**MCKINNEY BUILDING**  
 405 RANCH TRAIL  
 ROCKWALL, TEXAS 75032  
 RAINBOW ACRES, LOTS 18 & S PART OF 19  
 ROCKWALL COUNTY  
 MCKINNEY BUILDING

DEPARTMENT	REVIEWER	DATE OF REVIEW	STATUS OF PROJECT
POLICE	Chris Cleveland	02/22/2023	Approved

DEPARTMENT	REVIEWER	DATE OF REVIEW	STATUS OF PROJECT
PARKS	Travis Sales	02/21/2023	Approved w/ Comments

CPV-354 RANCH TRAIL LLC MAVERICK RANCH BLOCK A, LOT 2 ACRES 1.360

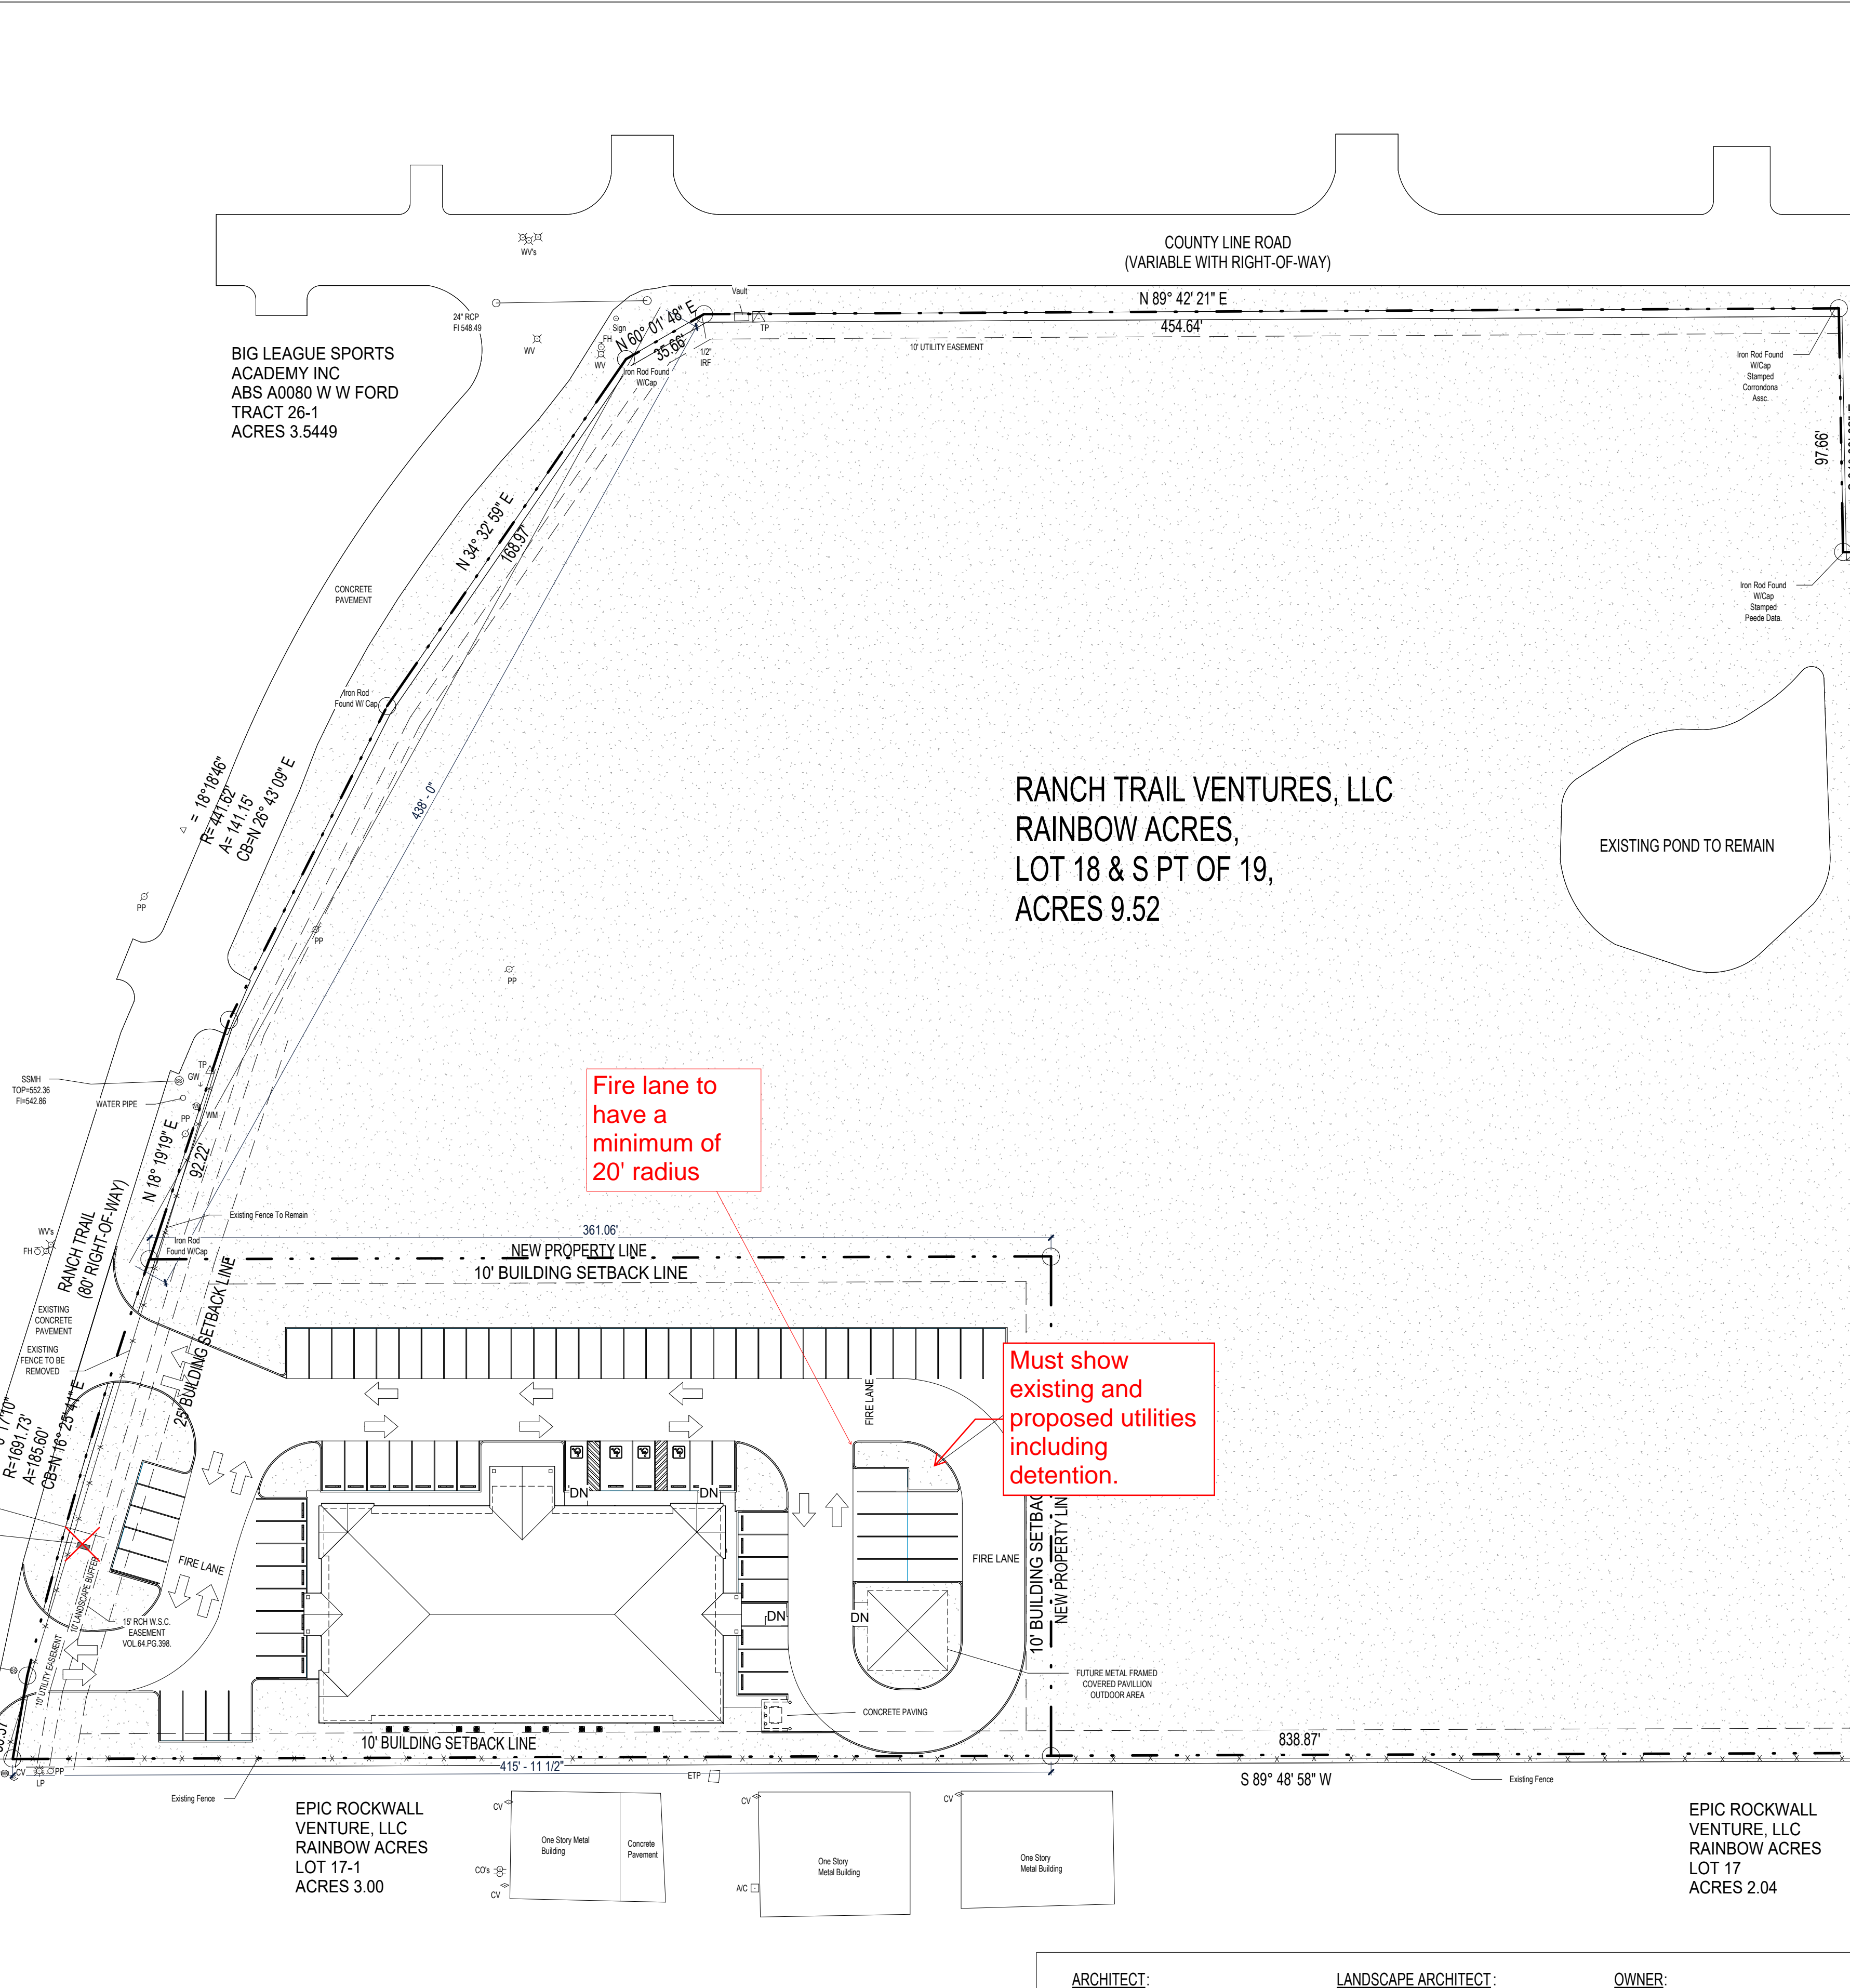
Remove signage from plans. Must have a separate permit through Building Department

Fire lane to have a minimum of 20' radius
